Docket Item #12  
BAR CASE# 2005-0198

BAR Meeting  
October 5, 2005

**ISSUE:** Rear Dormer and window replacement

**LOCATION:** 206 South Fayette Street

**Figure 1** Rear elevation

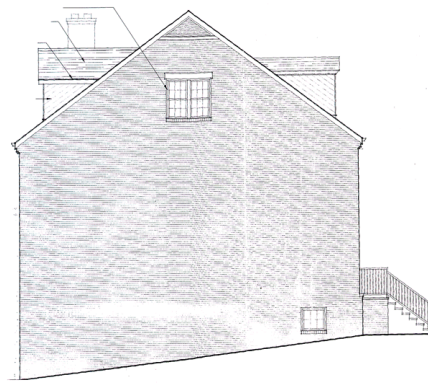
The overall mass and scale of the proposed dormer is consistent with the scale and fenestration of the rear elevation of the house.

The applicant should submit catalog cuts on the proposed windows to ensure compliance with the *Design Guidelines* for windows.

Staff recommends approval of the application with the condition that the window selection be approved by Staff.
